MOTOROLA

MC68360

Errata and Added Information to **MC68360 Quad Integrated Communication Controller User's Manual Rev 1**

January 8, 1998

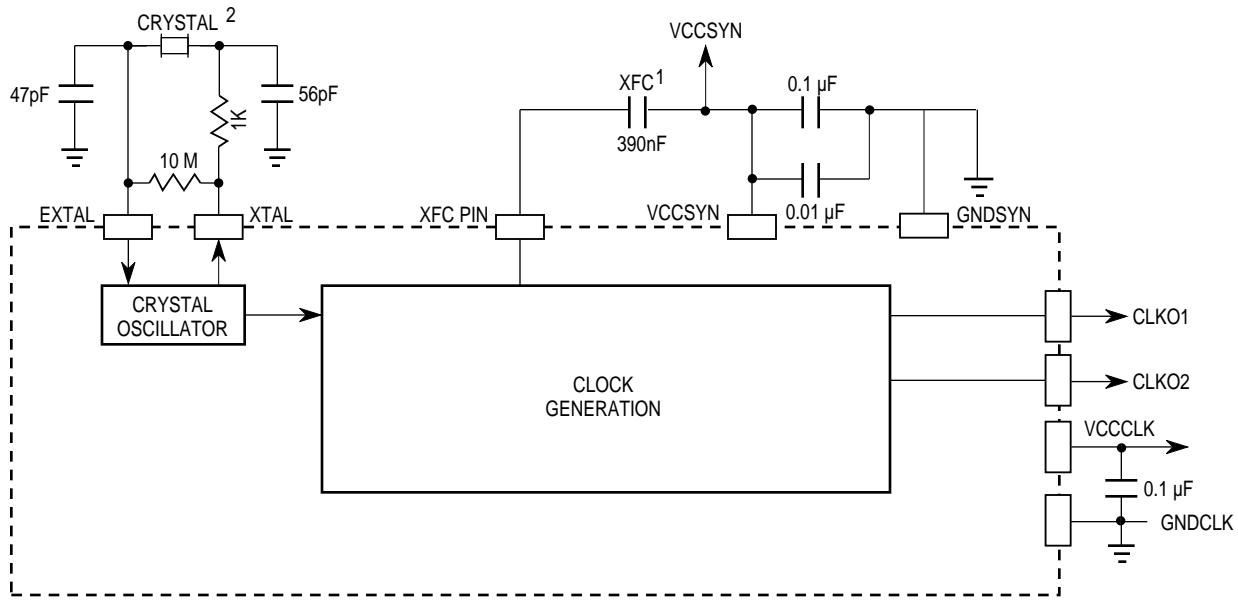
6.5.1.2 Using Crystal as Input Clock

The 68360 has the ability to use a low speed crystal as its clock source. The on-chip PLL can multiply the output of the crystal circuit up to the final system frequency. A crystal circuit consists of a parallel resonant crystal, two capacitors, and two resistors. Example values for both a 32kHz crystal and a 4MHz crystal are shown in Figures 6-6 and 6-6A. Note that these are example values. Your circuit may require slightly different values to operate properly. Crystals are typically much cheaper than similar speed oscillators. However, they may not be as stable since they are affected by parameters such as: trace length, component quality, board layout, 68360 package type, 68360 shrink level, etc. While crystal circuits are typically stable, it is impossible to guarantee that they will remain stable due to 68360 process changes or external component shifts.

Figure 10-44(b) MC68040/EC040 SRAM Write cycle (TSS40=0, CSNT40=1)

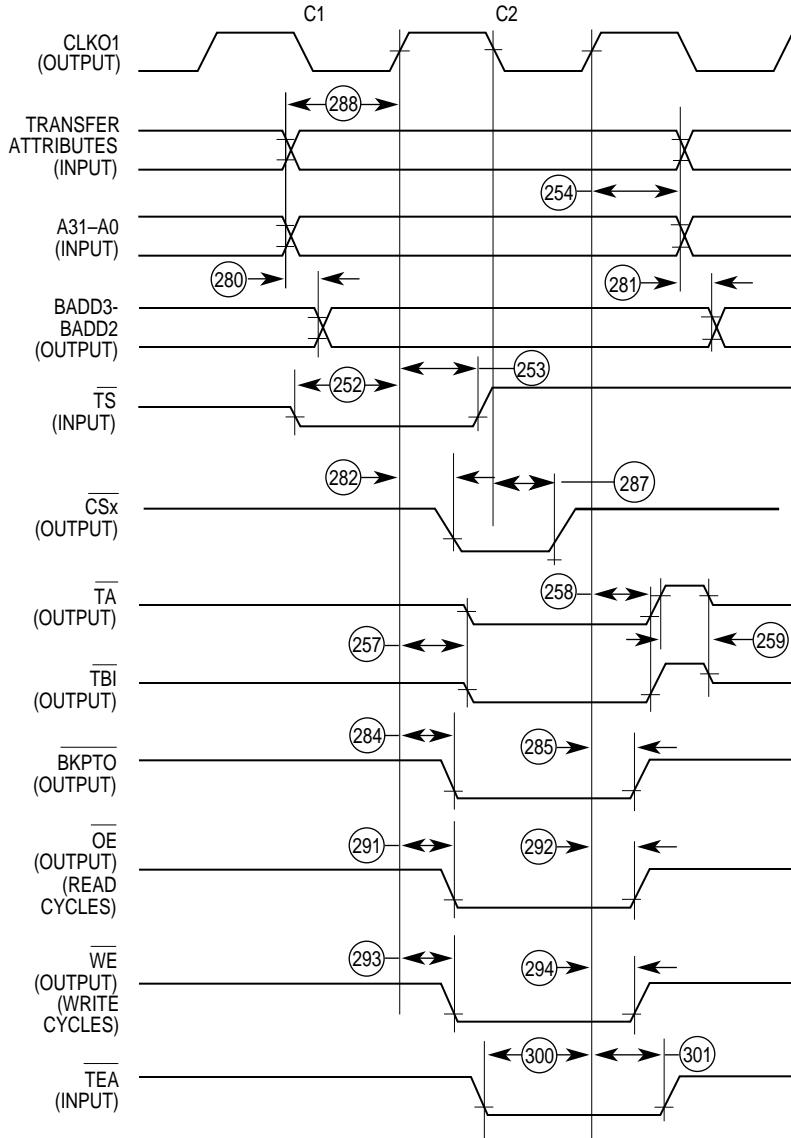
The following figure should be added after figure 10-44(a)

Figure 10-45(b) MC68040/EC040 SRAM Read Cycle (TSS40=1, CSNT40=1)

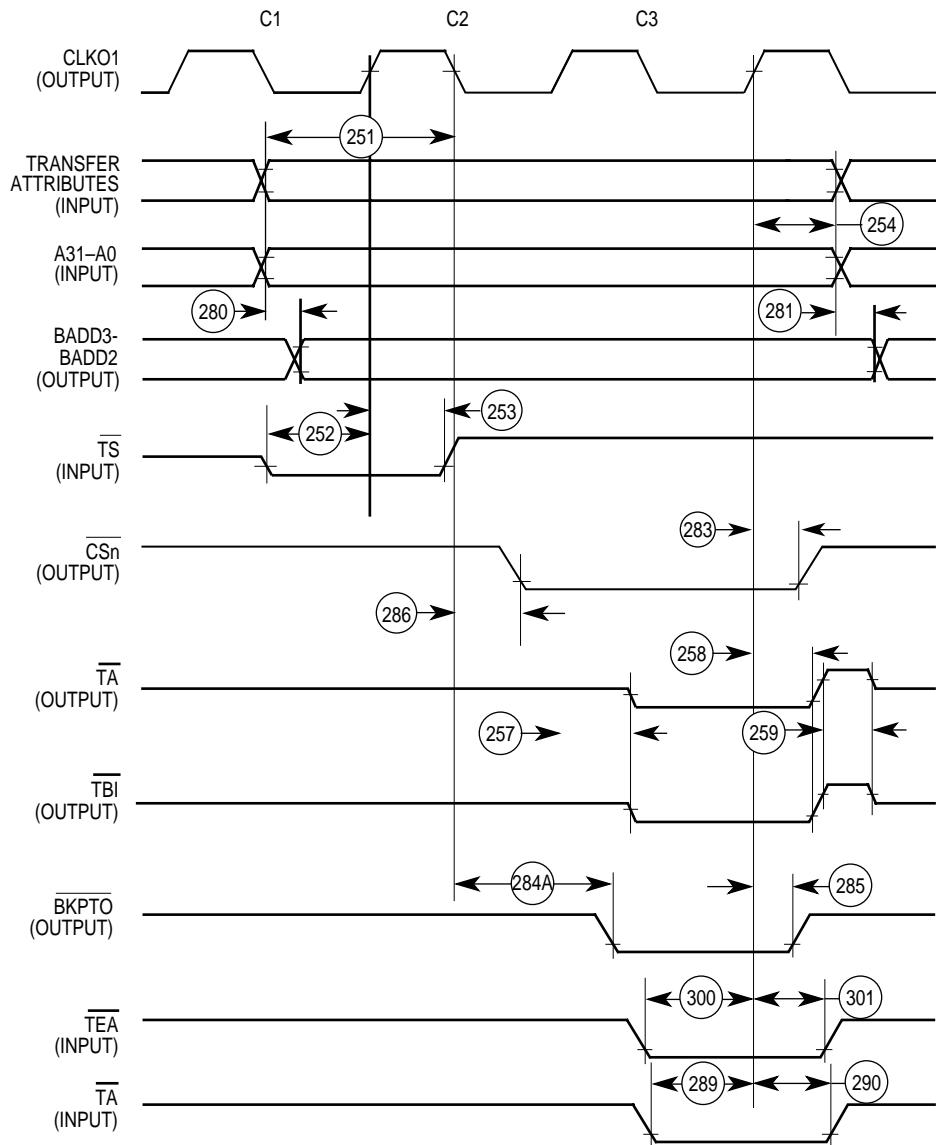
$\overline{\text{OE}}$ and $\overline{\text{WE}}$ signals are not supported when TSS40 is set to 1.

The following figure should be added below figure 10-45(a)
